# Assessment of Dam Safety Coal Combustion Surface Impoundments Draft Report

American Electric Power  
General James Gavin  
Power Plant  
Cheshire, Ohio

July 2, 2009

CHA Project No. 20085.4000.1510

IMAGE REFERENCE: BBC&M BOTTOM ASH POND STABILITY  
ANALYSIS REPORT, APPENDIX D, PAGE 13

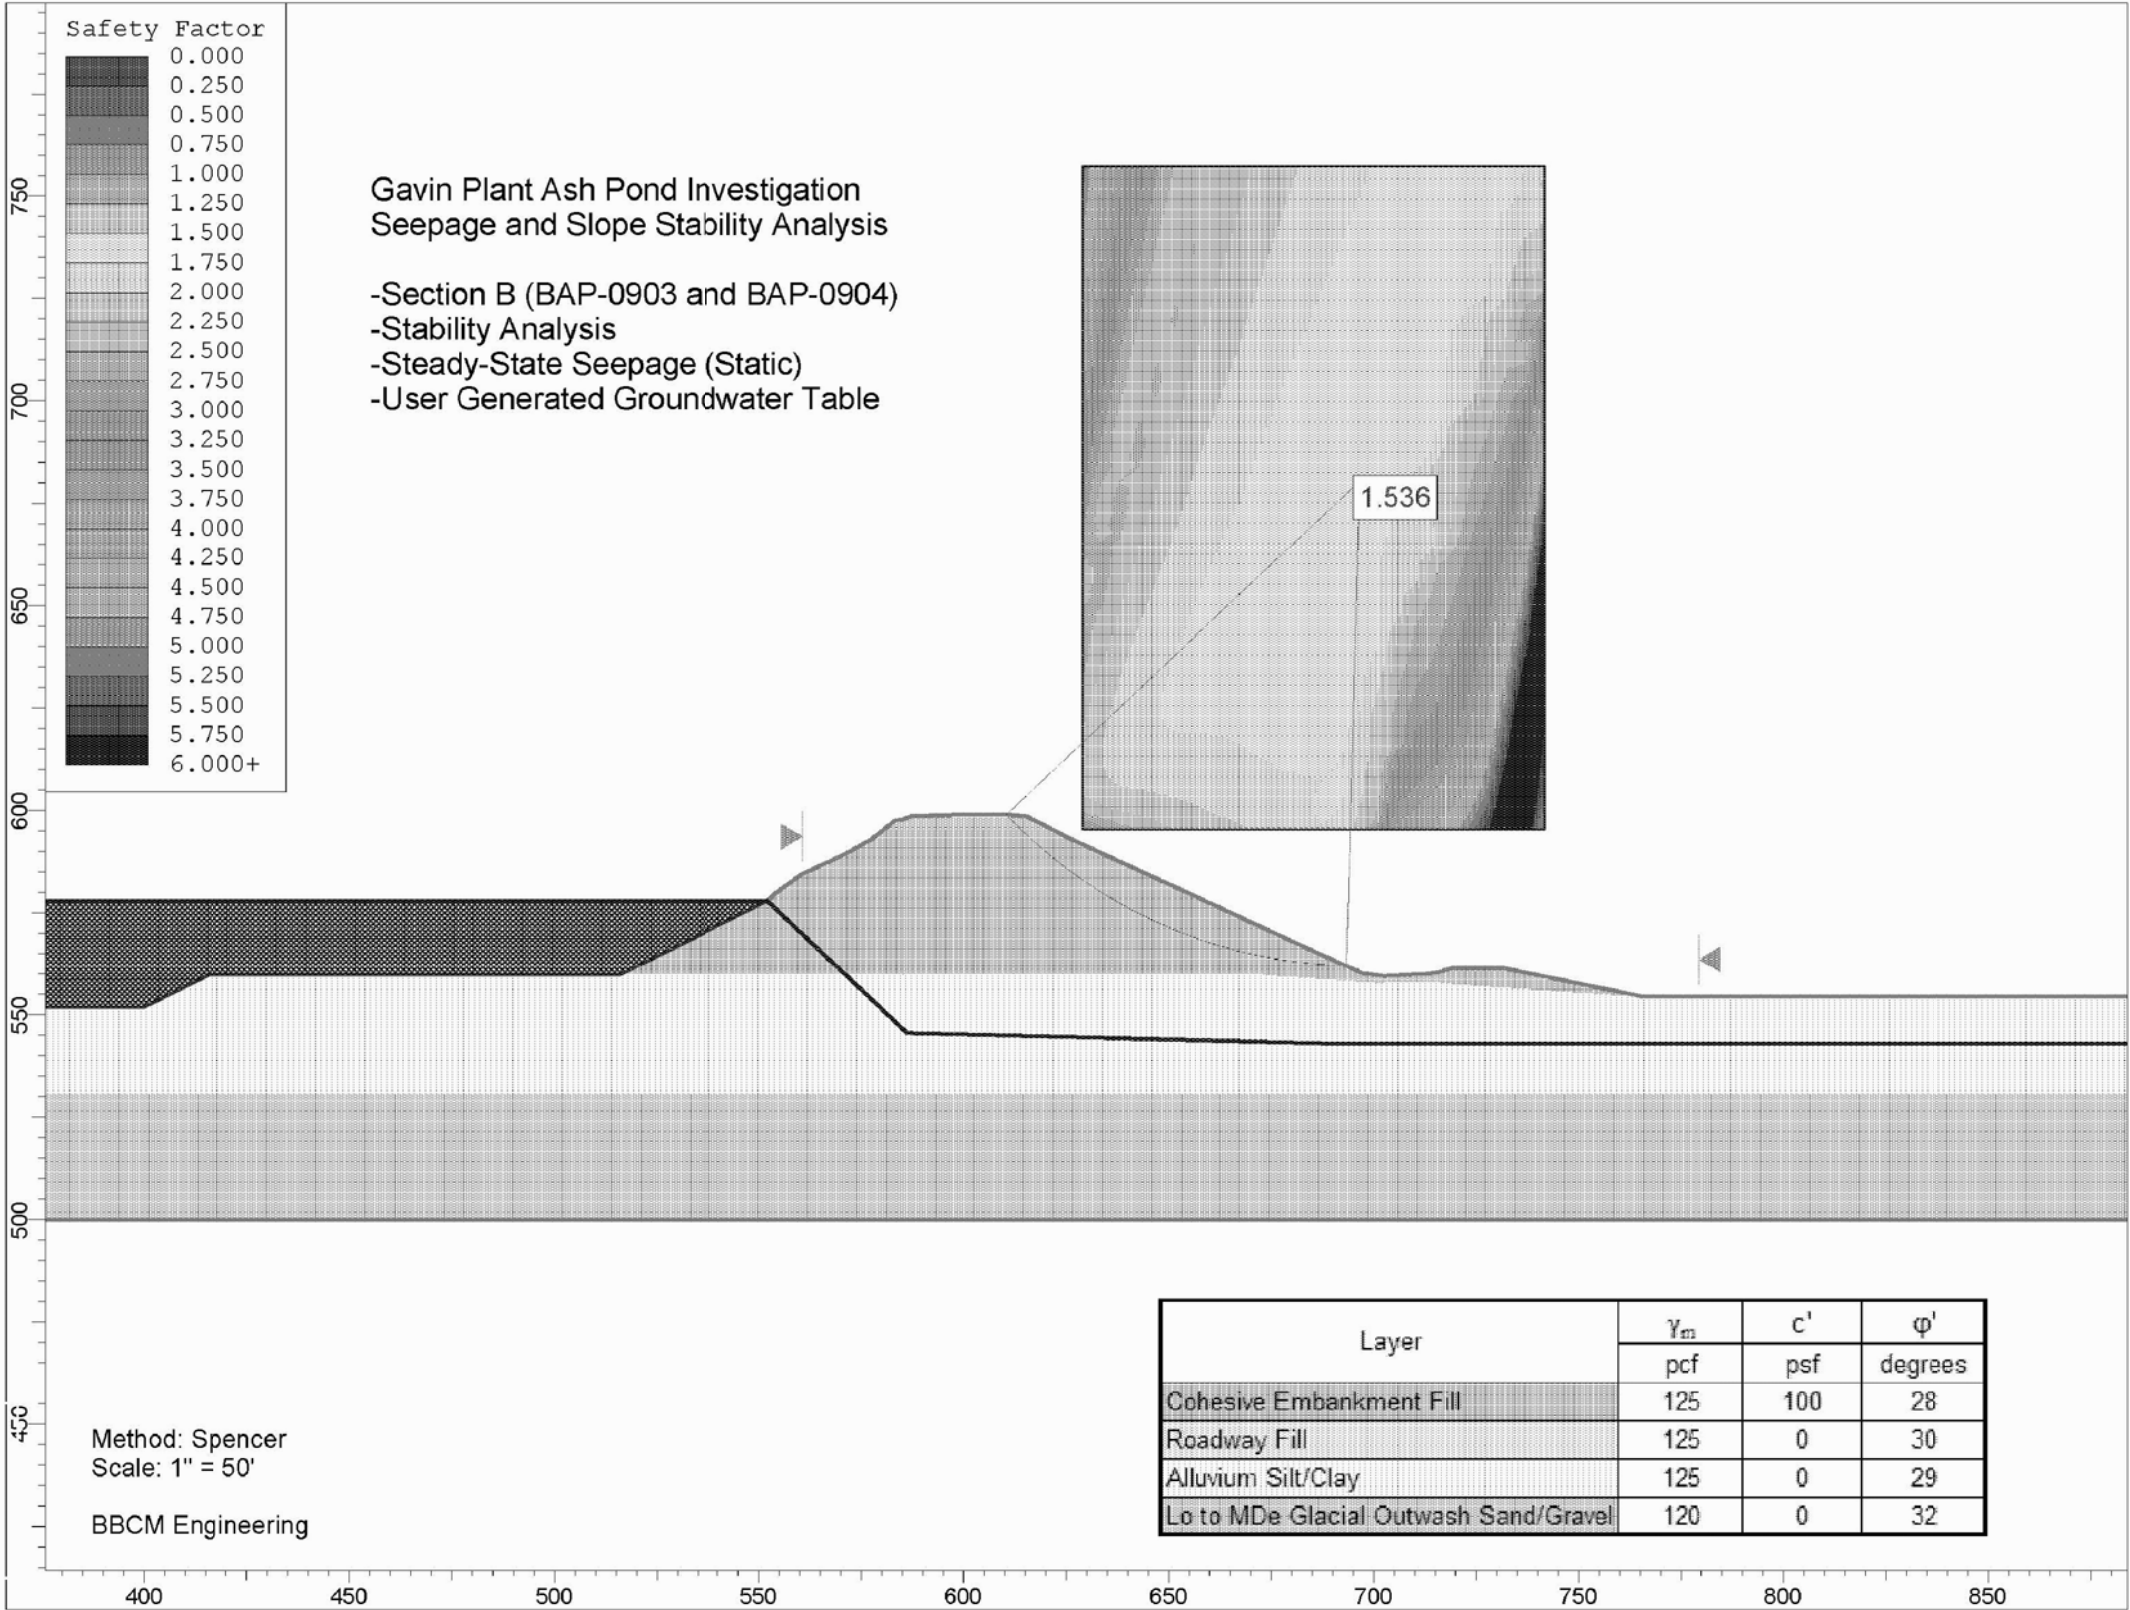
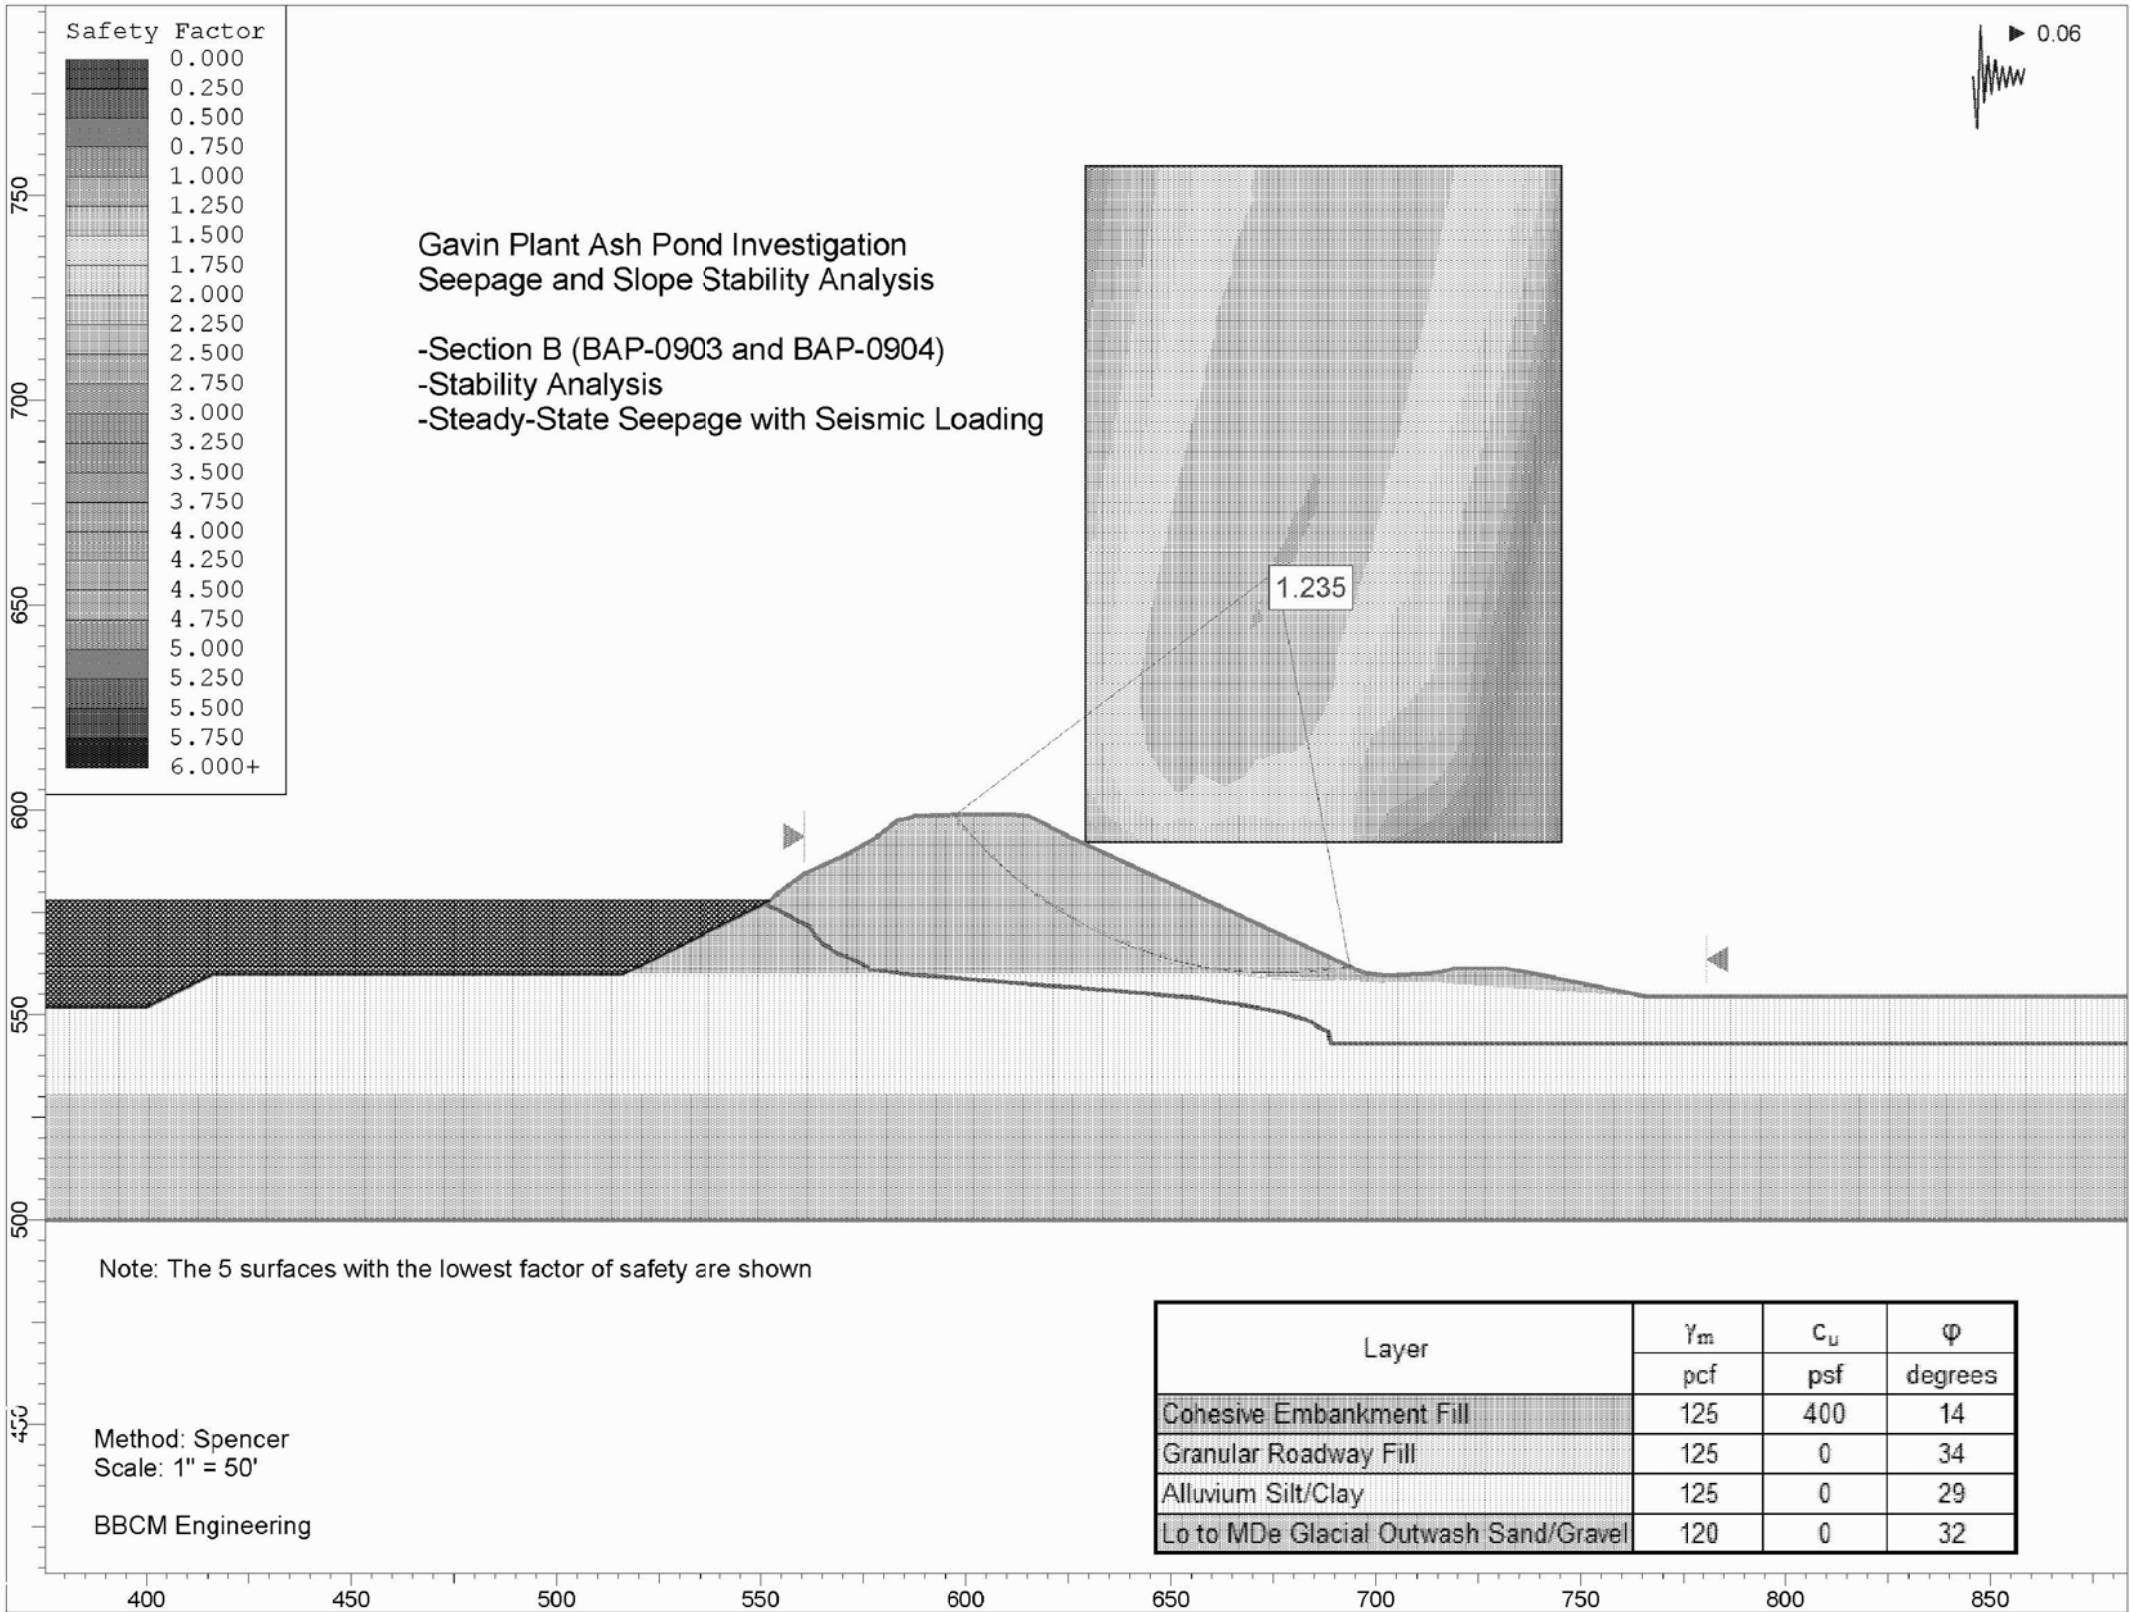
- The downstream slope stability outputs for the steady state load condition for Cross Sections A and B show failure planes within the embankment soils. If the alluvium silt/clay was modeled with a soft layer at the depth corresponding to the low sample effort the failure plain may actually fail within the alluvium foundation soils and not the embankment soils. We recommend that a model be prepared for this load case using the soil parameters for the soft alluvium layer described above.

- We recommend that an investigation be performed in which the properties of the alluvium silt/clay layer can be investigated in more detail in order to determine the presence and thickness of the soft layer of material indicated in the boring logs from June 2009. This scope of work should include laboratory testing of samples retrieved from the alluvium layer.

FIGURE 9A

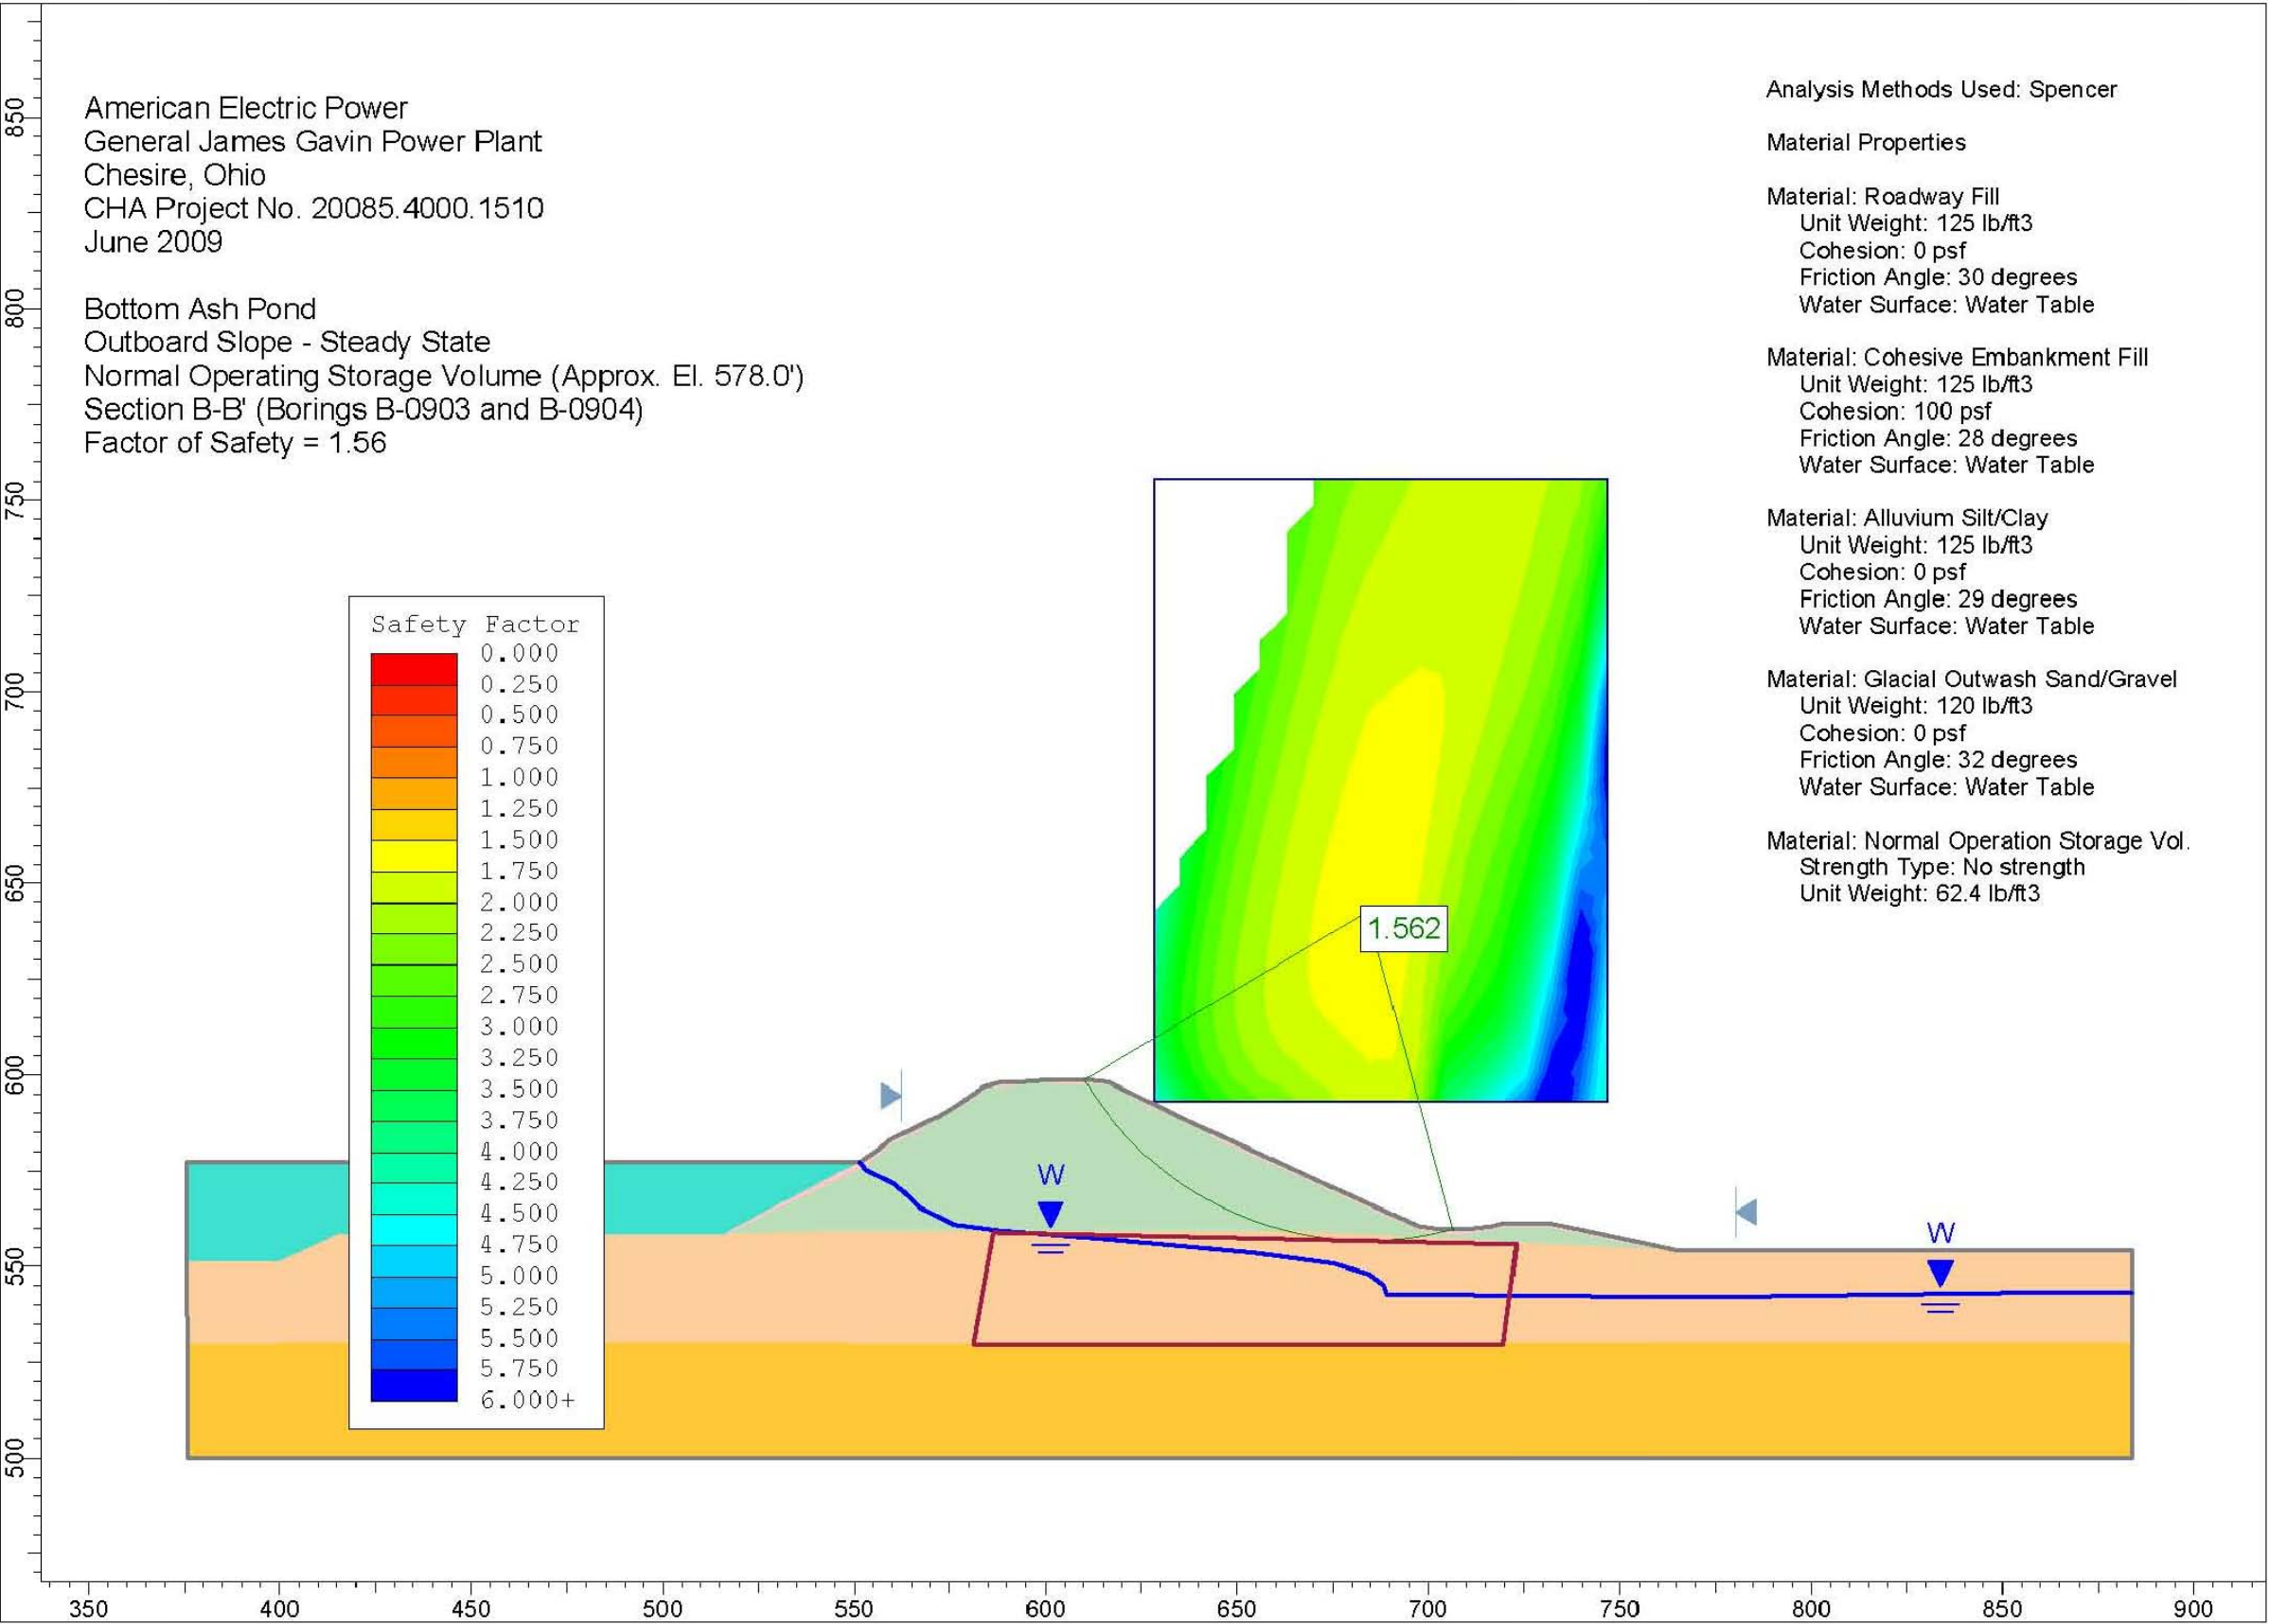
the factor of safety for this load case provided in the report. Our Slide™ output resulted in a similar factor of safety as shown on Figure 9A.
